CPP Project 13530

Attn: Tracy Hoven
Project: 338 Pitt Street

This memo will address City of Sydney's RFI for the above project [1] and specifically items 8 and 9 which relate to pedestrian wind comfort. CPP has previously prepared a preliminary wind comfort study [2] based on a simplified massing model of the proposed development. This study was based on limited wind tunnel testing and intended to provide a broad overview of wind impacts at the site. Generalised in-principle recommendations for mitigation measures were provided based on this study and a number of these have since been incorporated into the design. This memo will provide an update to CPP's advice in light of these changes, noting that further detailed wind tunnel testing will be required to adequately assess pedestrian wind comfort in conjunction with further detailed design.

Figure 1: L36 Sky Bridge plan.

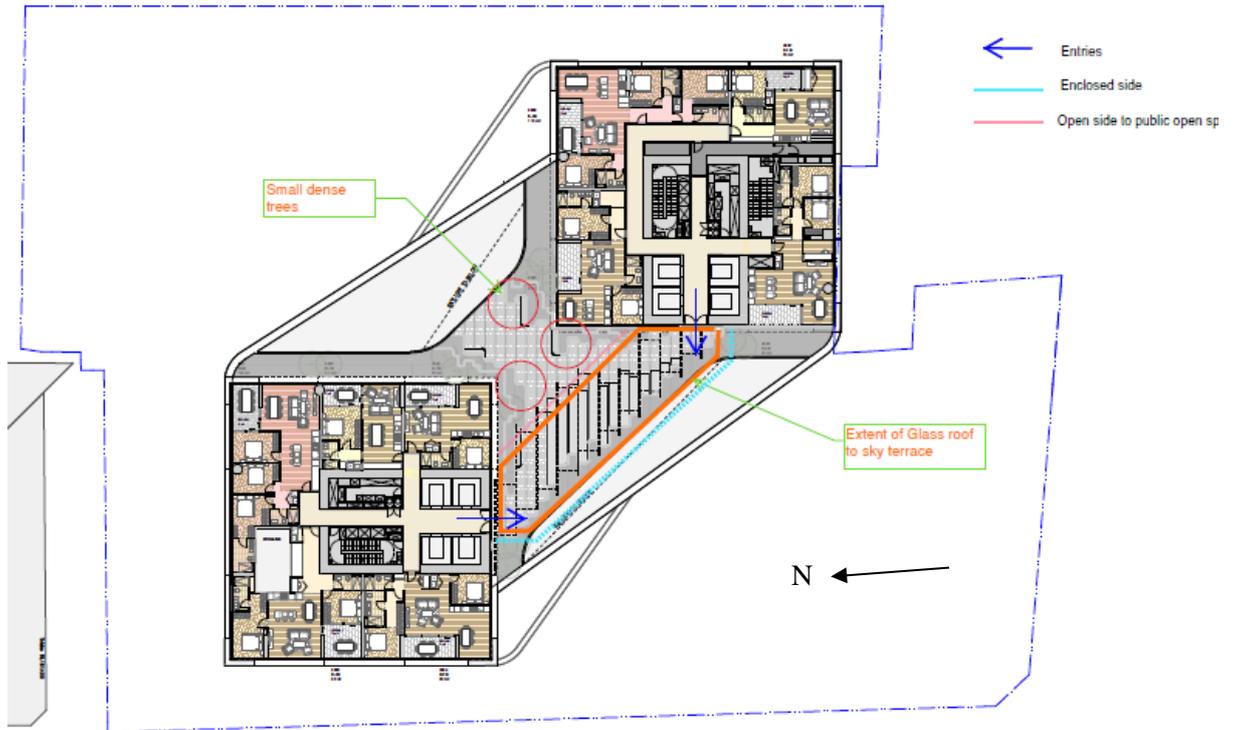
Preliminary wind tunnel testing on the L36 Sky Bridge indicated conditions were Uncomfortable or suitable for Business Walking under the criteria of Lawson [3]. The Sky Bridge area will be exposed to strong winds from multiple directions. The layout of this area has been revised to include overhead coverage to the terrace area with full-height screening on the southern elevation, Figure 1. Relative to the tested design, this addition will provide significant improvement to wind amenity by discouraging flow from traversing across the accessible space between the two towers and providing a location that is protected from vertical downwash flow from the towers above. On the northern side, vegetation is proposed to form a buffer zone from the towers. For this area, vegetation or landscaping is not considered a sufficient means of mitigating strong winds. Additional treatments such as a full-height perimeter screen and/or overhead canopy structure(s) may be required to allow conditions commensurate with Pedestrian Sitting comfort. The extent of these mitigation options will be determined by further wind tunnel testing. It is noted that a Pedestrian Sitting comfort rating is a reasonably stringent requirement for an outdoor terrace in Sydney. Such a comfort rating is likely to be achievable under the enclosed section of the terrace, however may be difficult to meet across the whole terrace without similar enclosure. Testing will be necessary to confirm.
